Application No.: 10/761,984

Docket No.: JCLA11903

REMARKS

Annotated Marked-up drawing**FIG. 2A****FIG. 2B(PRIOR ART)**

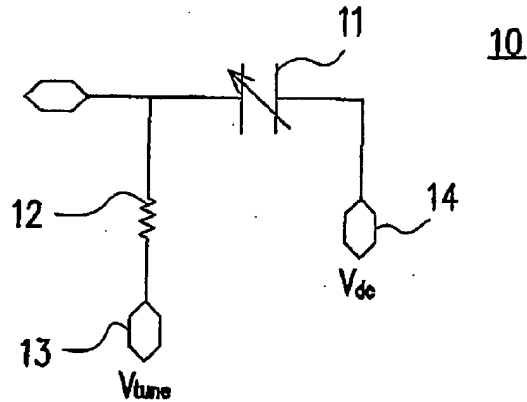
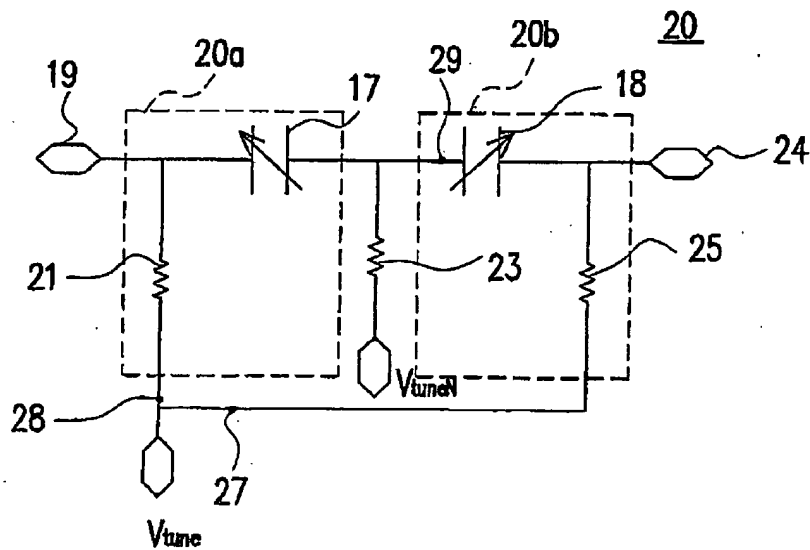
FIG. 1A, FIG. 1B, and FIG. 2B have been amended to include the missing "Prior Art" designation as stated by the Examiner in the Office Action. They are presented in the appendix.

Annotated Marked-up drawing**FIG. 1A(PRIOR ART)****FIG. 1B(PRIOR ART)**

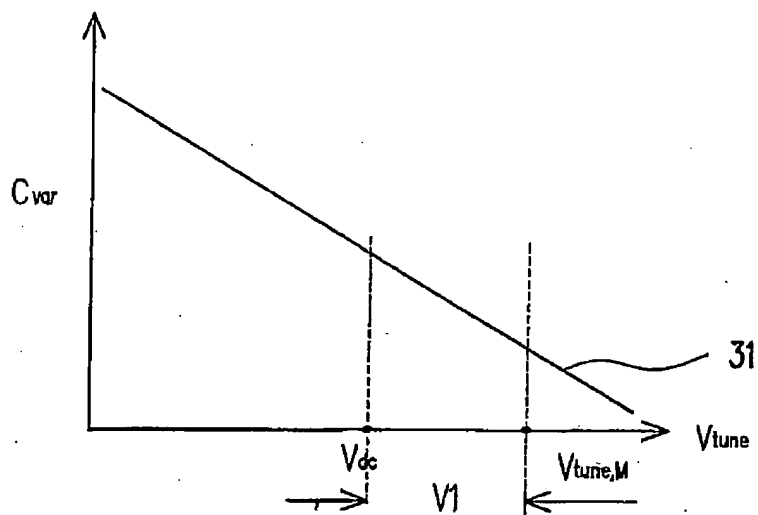
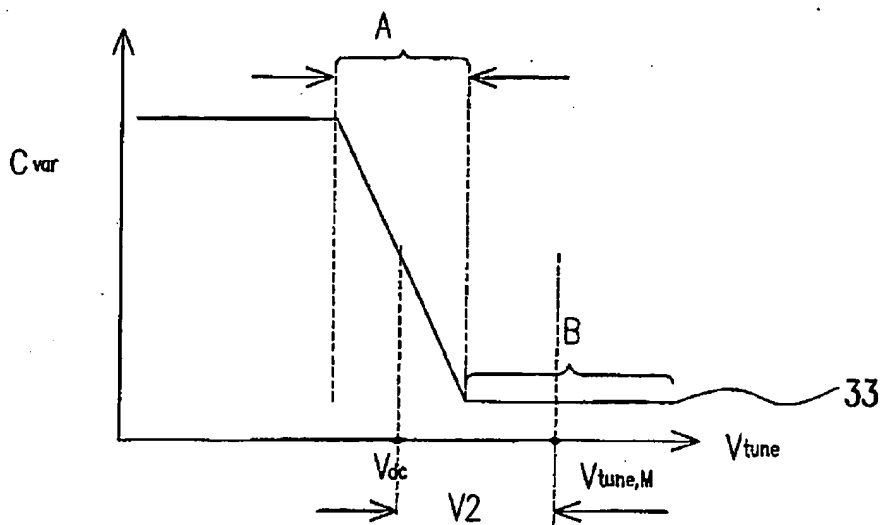
Figures 1A, 1B and 1C were objected to because the legend "Prior Art" should be added. The Office Action objected claim 4 as having minor errors. Claims 4-7 are pending. Claim 4 is rejected under 35 U.S.C. 102(b) as being anticipated by Scoggins (US-6,469,587, "Scoggins" hereinafter). Applicants have amended claim 4. After entry of the foregoing amendments, claims 1-7 remain pending in the present application, and reconsideration of those claims is respectfully requested.

FIG. 1A, FIG. 1B, and FIG. 2B have been amended to include the missing "Prior Art" designation as stated by the Examiner in the Office Action. They are presented in the appendix.
